TLG Rule Modification for event \$1B

G. Vogel 12-18-2001

Timeline for previous TLG Rules for placement of \$1A & \$1B events

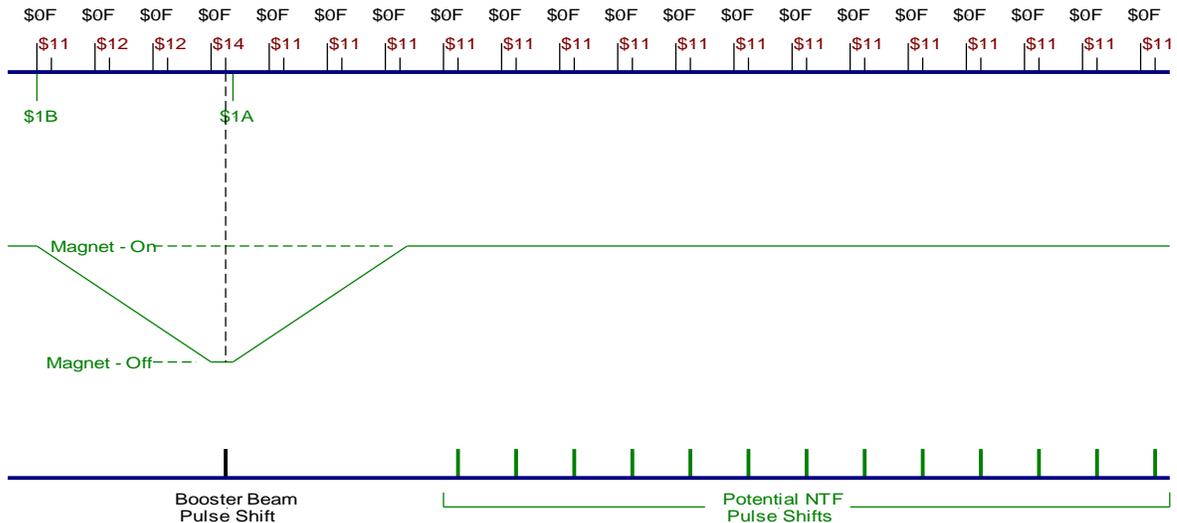
\$1B - 3 ticks prior to booster beam reset

\$1A - 2mS after BB reset if 14 open ticks before next BB reset

(Magnet On/Off shows former rise/fall time)

Timeline for previous TLG Rules for placement of \$1A & \$1B events (with faster magnet ramp)

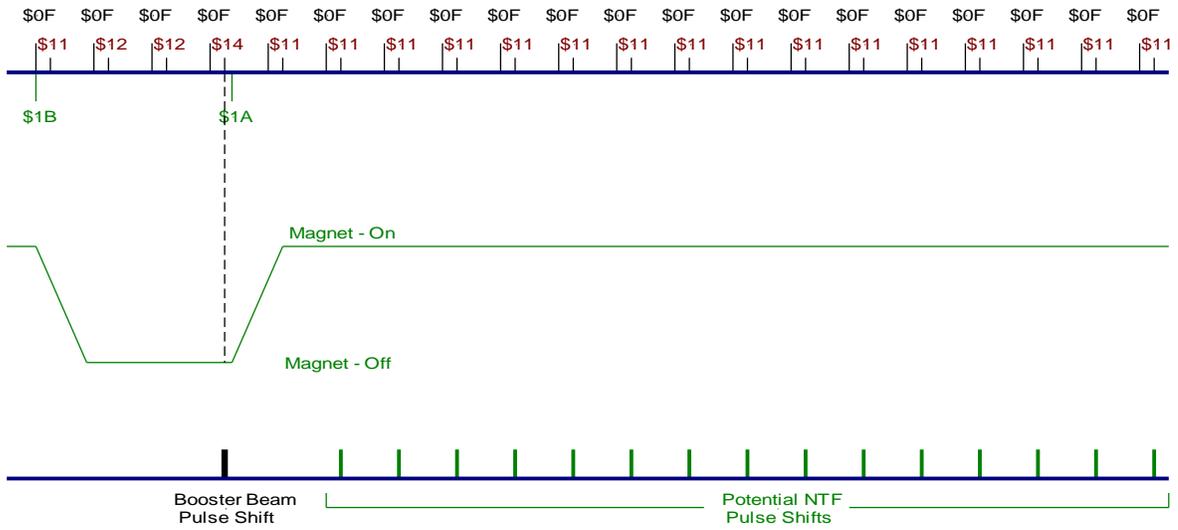
\$1B - 3 tick prior to booster beam (BB) reset
 \$1A - 2mS after BB reset if 14 open ticks before next BB reset

Timeline for present TLG Rules for placement of \$1A & \$1B events

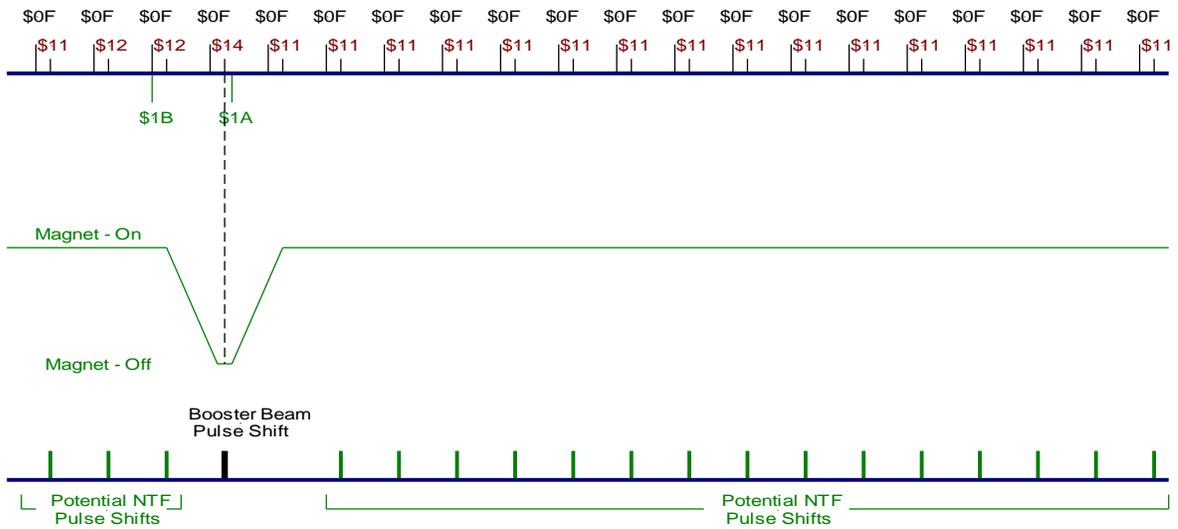
In order to support future operations in which MiniBooNe and NTF will be required to coexist, the ramp time for the NTF 58 degree magnet has been sped up from approximately 200 mSec. rise/fall time to approximately 60 mSec. This nullified the need to place the TCLK \$1B event (which turns off the 58 degree magnet) 3 full 15 Hz ticks ahead of the booster beam reset (\$13, \$14, \$15, \$16, \$17, \$19, \$1C and \$1D) in order to avoid interference. Instead it now only needs to occur a single 15 Hz tick ahead. Therefore, we have changed the TLG FE rule for placing \$1B. It is now placed 1 full 15 Hz tick ahead of the Booster beam reset. It plays out in the timeline 2 uSec. ahead of the \$0F (15 Hz clock event) and approximately 83 mSec. ahead of the associated Booster Beam reset. (Booster Beam resets play out approximately 17 mSec. after the \$0F.)

\$1B - 1 tick prior to booster beam (BB) reset
 \$1A - 2mS after BB reset if 14 open ticks before next BB reset
